10000 AVE., WINDY ISLAND 64-2-2

CITY OF PORTLAND, MAINE  
DEPARTMENT OF BUILDING INSPECTION

# APPLICATION FOR PERMIT

To demolish existing 2-story frame storage building.

COMPLAINT NO. 64/16 Date Received March 5, 1964

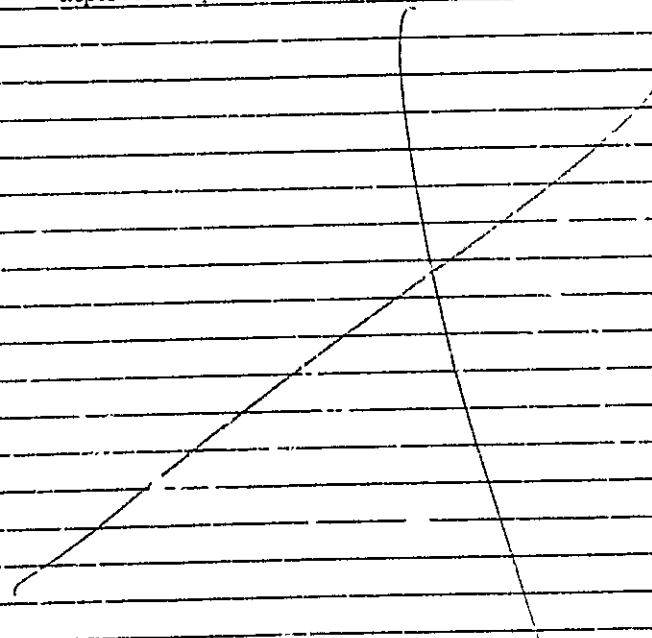
Description: A pane of glass is loose in second story window facing over the sidewalk.

NOTES: Reported complaint to Mrs. MacVane who said she would take care of it. GEN
